STAFF RECOMMENDATION
519 Acklen Park Drive
May 16, 2018

Application: New construction – infill and outbuilding (revision to previously approved project)

Description of Project: The applicant seeks to construct a new single-family home with a detached outbuilding that does not include a dwelling unit. This application is a revision to a previously approved infill and outbuilding.

SITE PLAN
SCALE: 1" = 20'-0"

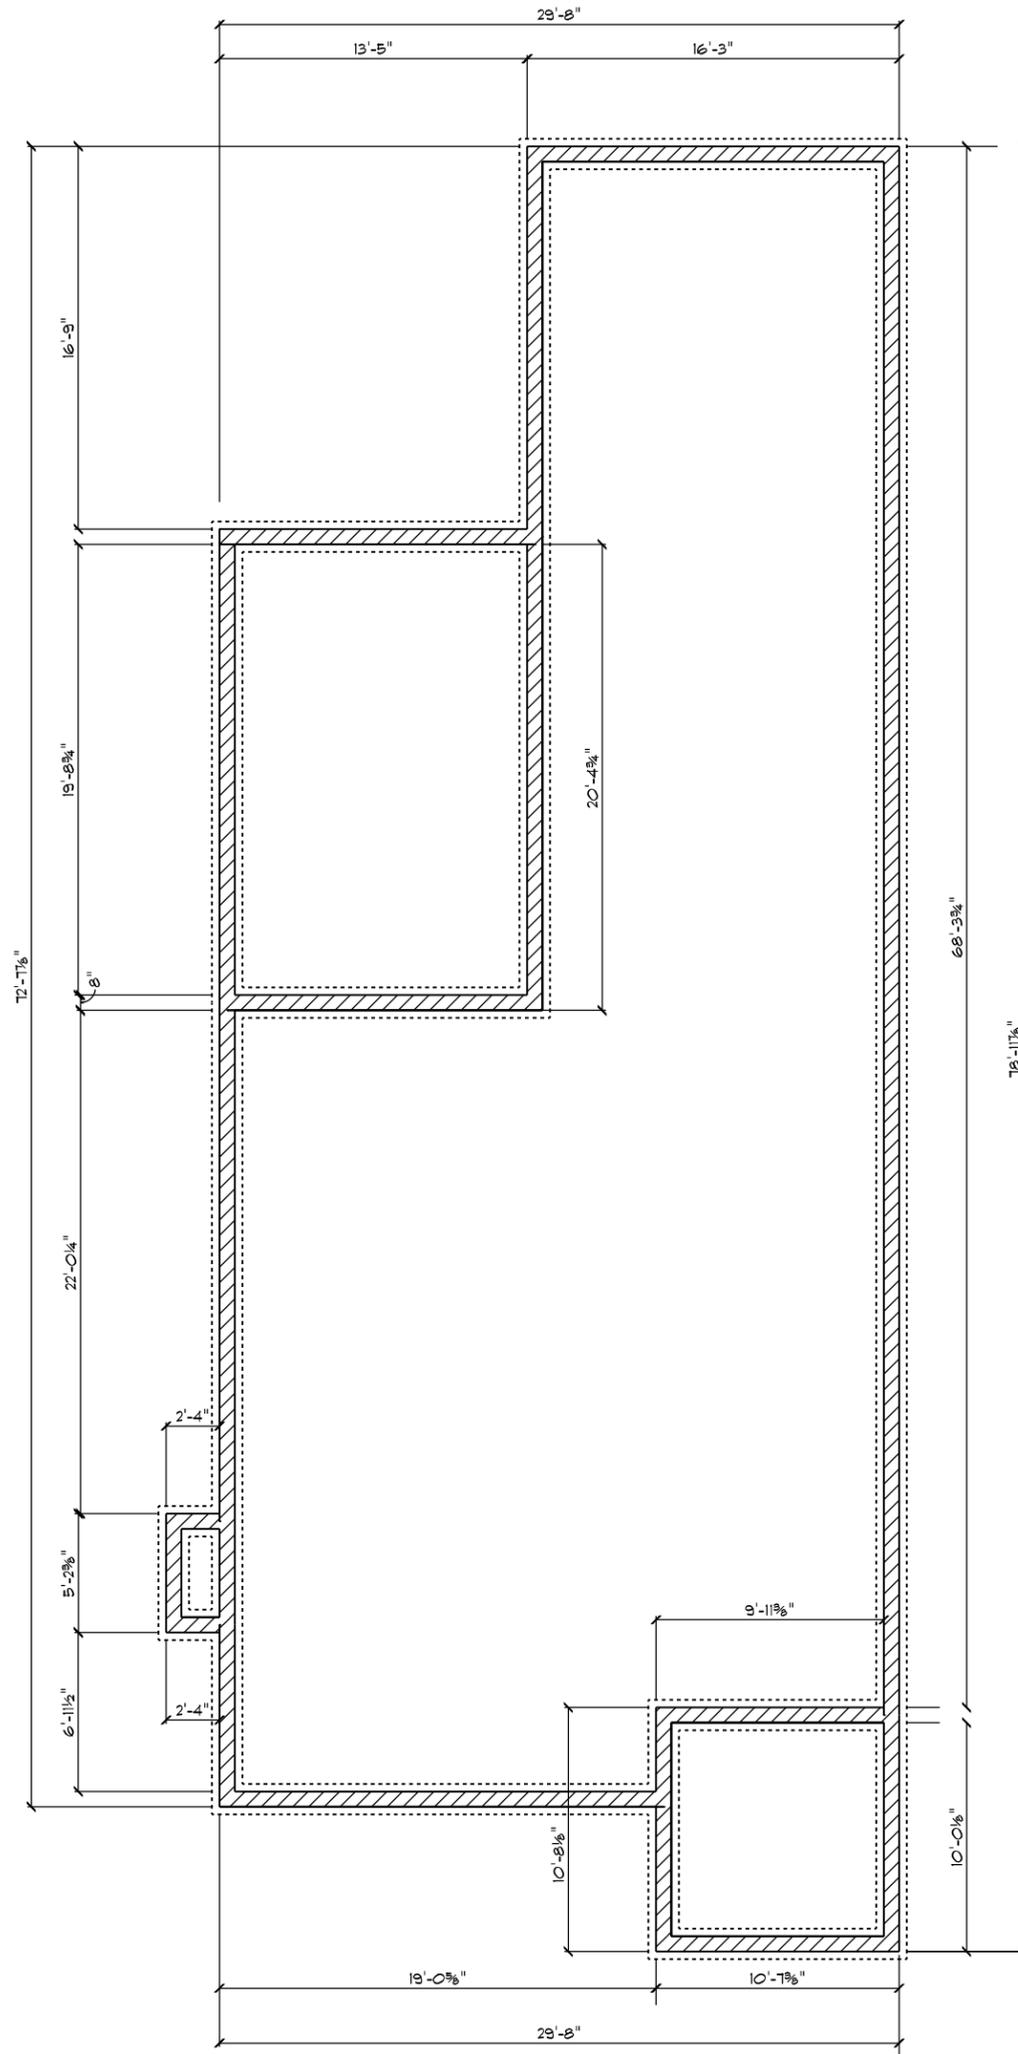
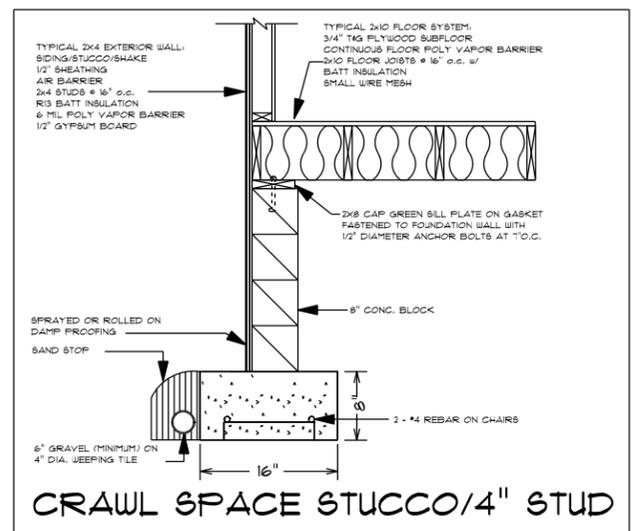
Setback & Rhythm of Spacing: The front of the property is angled to the street, and the lot widens toward the rear. The new building will be located with the left-front corner approximately thirty-one feet, seven inches (31'-7") to the street, which is consistent with the front setbacks of existing houses on the street. The side setbacks will be approximately eight feet (8') on the left and six feet (6') on the right. The proposed infill will have a rear setback of sixty-nine feet (69'). The setbacks meet the requirements of the zoning code and are compatible with the surrounding context. The proposed setbacks and rhythm of spacing will be compatible with the surrounding context and will meet Section II.B.1.c of the design guidelines.

Appurtenances & Utilities: Per the applicant, vehicular access will be from the alley. The applicant would like to retain the existing front drive to use as a parking pad for guests. Staff recommends that the front driveway be removed since vehicular access is to be relocated to the alley. In addition, a front parking pad is inappropriate as it was not common historically and the Commission has not approved front parking pads in the past. The location of the HVAC and other utilities was not noted. Staff recommends that the driveway be located off the alley and that the HVAC would be located on the rear façades, or on side façades beyond the midpoints of the houses, to ensure that the project meets Section II.B.1.i of the design guidelines.

1. The finished floor height shall be consistent with the finished floor heights of the adjacent historic house, to be verified by MHZC staff in the field;
2. Staff approve the roof color, porch floor and steps, porch posts, windows, doors, driveway material, walkway material, and a stone sample prior to purchase and installation;
3. The site plan shall incorporate a walkway leading from the front porch to the street;
4. The square window on the second level, left side, be proportional to the proposed window to the left to meet Section II.B.1.g;
5. The front driveway shall be removed; and
6. The HVAC be located behind the house or on either side, beyond the mid-point of the house.

FRONT ELEVATION

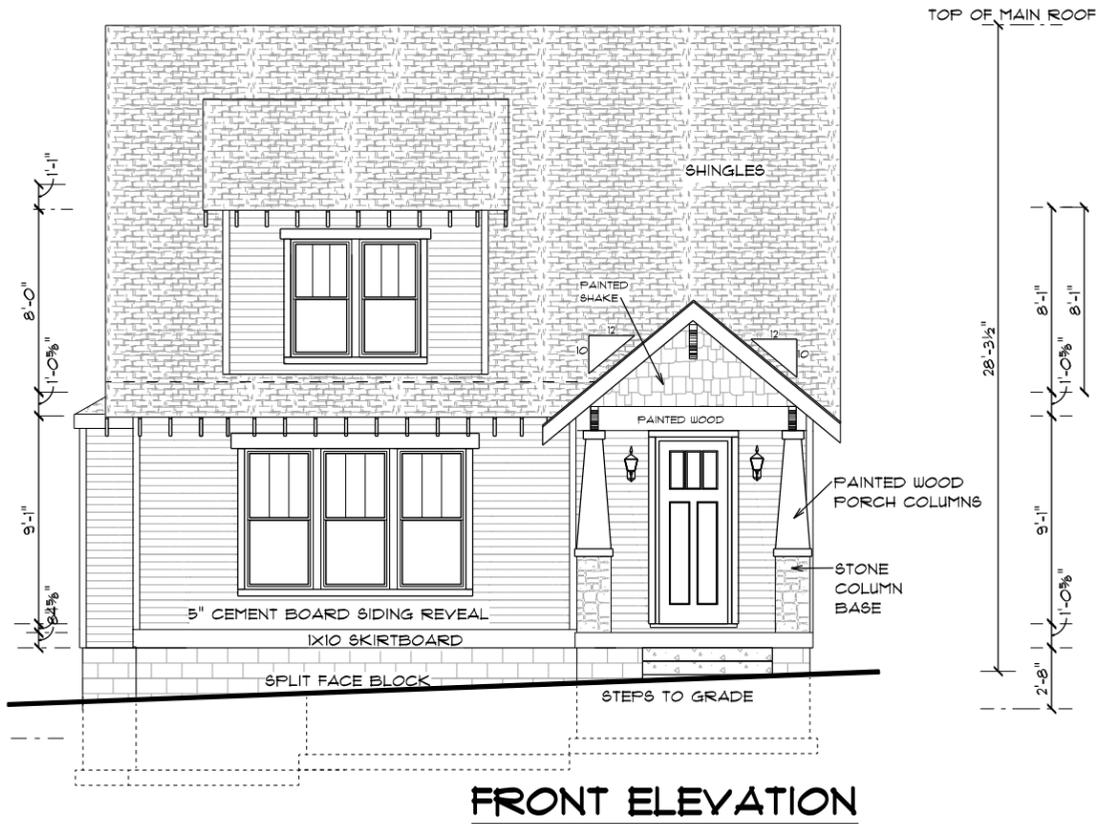
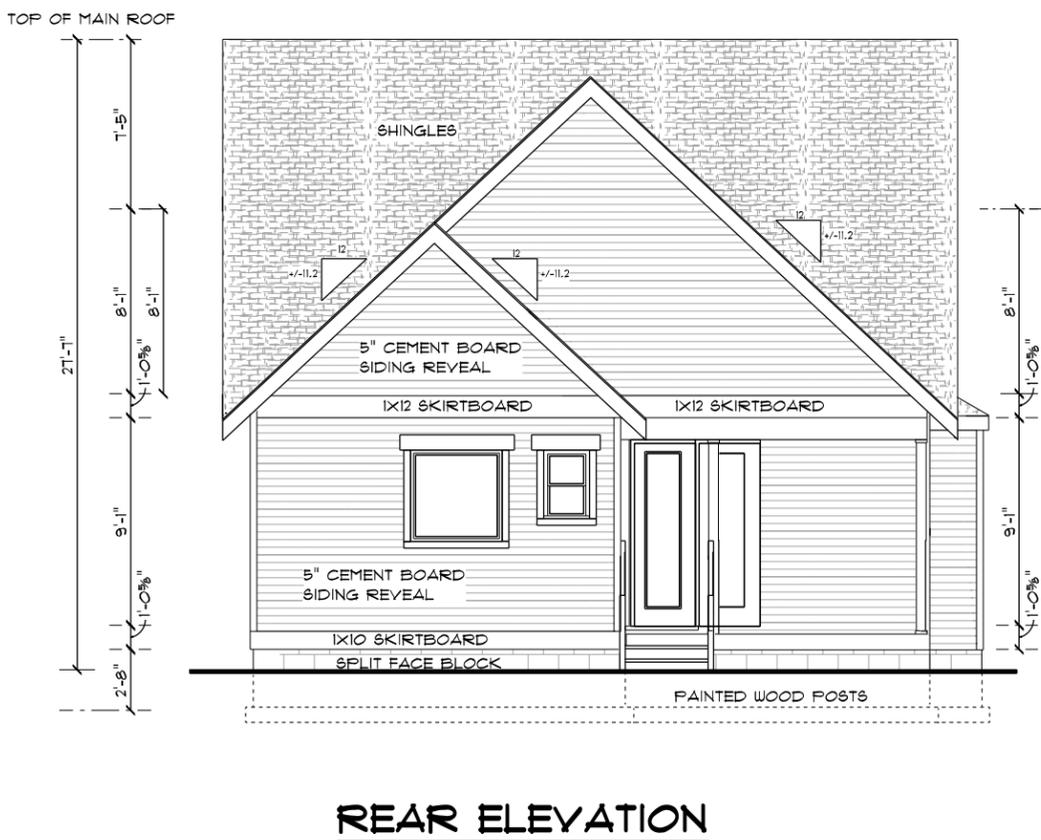
Roof form: The building will have a cross-gabled roof form with pitches of 8:12, 10:12, and 11:12. A shed dormer is proposed on the front façade with a 4:12 pitch. The front porch roof is

gabled with an 8:12 pitch. The roof forms and pitches are commonly found on historic houses throughout the neighborhood, and therefore meet Section II.B.1.e of the design guidelines.

Orientation: The new house will be oriented at an angle from the street, matching the orientation of the lot and existing houses on the street. The front of the building will have a nine foot, four inch (9'-4") deep partial-width porch addressing the street in a manner consistent with historic houses. Staff recommends that the plan incorporate a walkway leading from the front porch to the street. With the condition that the plan incorporate a front walkway, staff finds that the proposed infill will meet Section II.B.1.f of the design guidelines.

Proportion and Rhythm of Openings: Not all of the windows on the infill are all generally twice as tall as they are wide, which is typical of the historic proportions of openings. The side elevations include window proportions with some smaller, square windows on each side. Staff recommends approval of some the windows. The square windows on the ground floor are typical of small square windows that might historically be found flanking a chimney. The square window in the left gable field will be highly visible. Staff recommends that the proportions of the window be more in keeping with the proposed window to the left. Since the location is above at tub, the glass could be frosted for privacy. There are no large expanses of wall space without a window or door opening. With the condition that the square window on the second level, left side, be proportional to the proposed window to the left, staff finds the project's proportion and rhythm of openings will meet Section II.B.1.g of the design guidelines.

GARAGE MAIN FLOOR

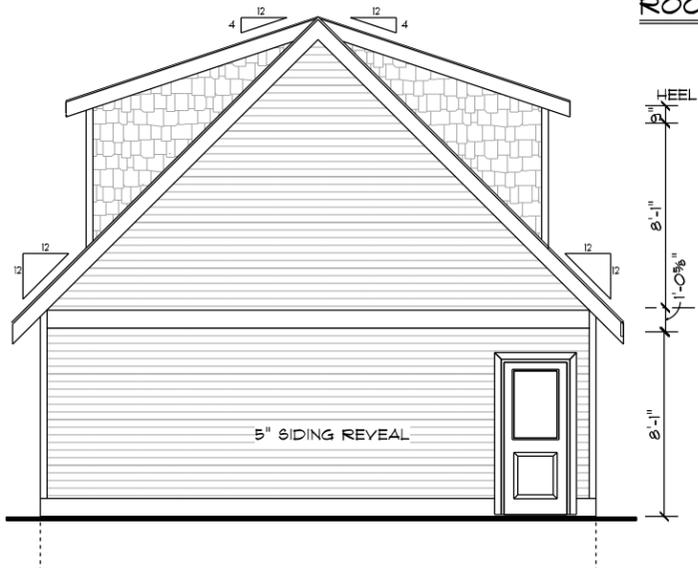
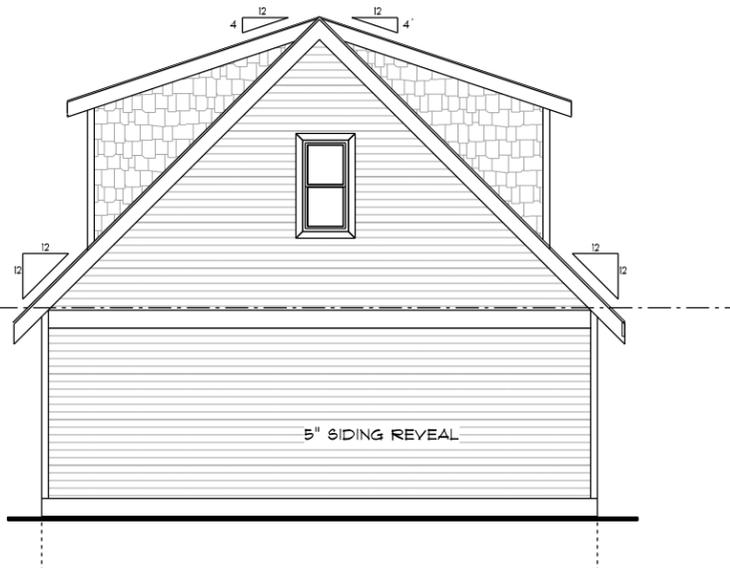
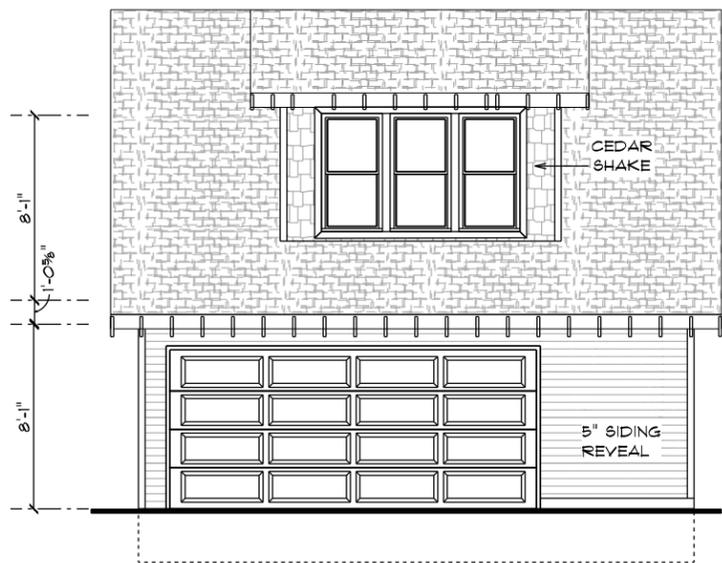
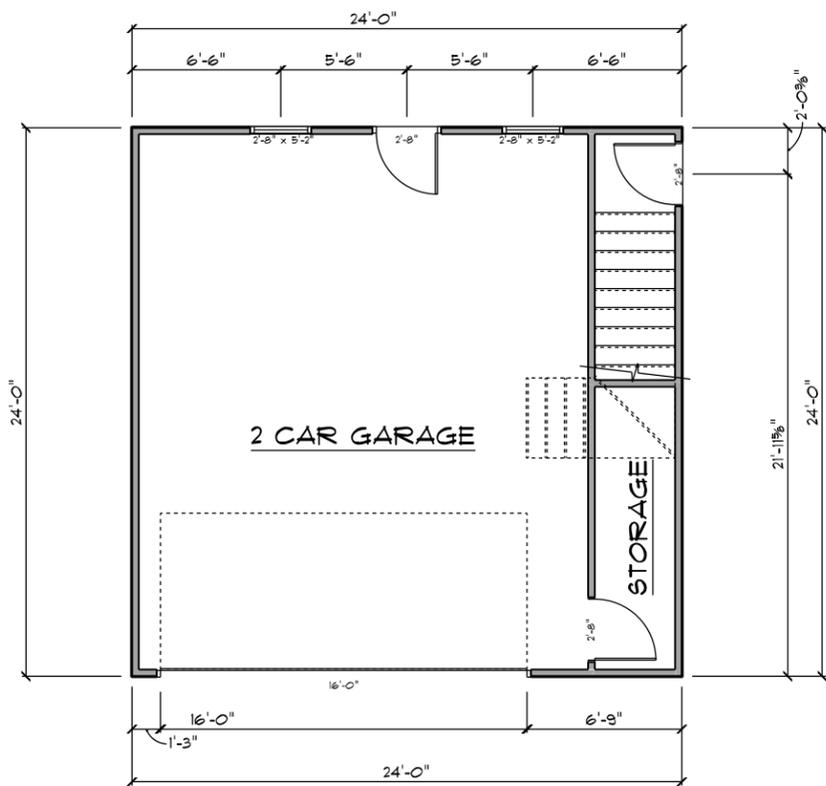
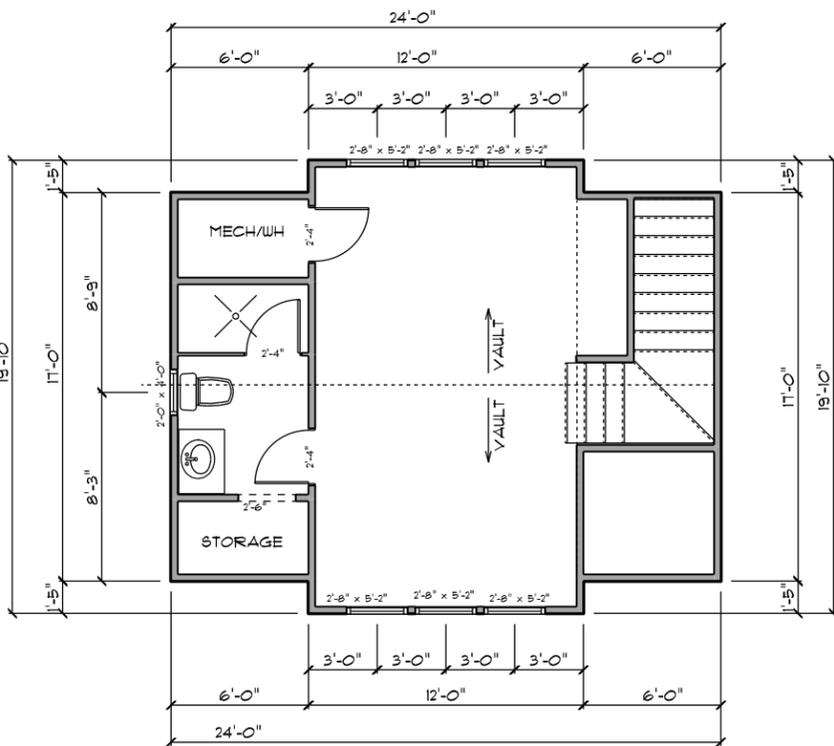
Design Standards: The materials, proportions, and overall character of the accessory structure will be compatible with the historic house. Its roof form and pitch will match that of the house, and the materials will not contrast greatly with the primary structure. The window proportions and locations are compatible with those of outbuildings historically. Staff finds the design of the proposed outbuilding to meet Section III.B.1.i.1 of the design guidelines.

Proposed Element	Proposed Form	Typical of district?
Primary form	Side gable	X
Primary roof pitch	12:12	X
Dormer form	Shed	X
Dormer pitch	4/12	X

YES	NO
If dormers are used, do they cover less than 50% of the roof plane where they are located as measured from side-to-side?	X	
If dormers are used, do they sit back from the wall below by at least 2'?	X	
Is the roof pitch at least 4/12?	Yes

With the condition that the roof color, window, and door selections are approved by MHZC Staff prior to purchase and installation, the project will meet Section II.B.1.i of the design guidelines.
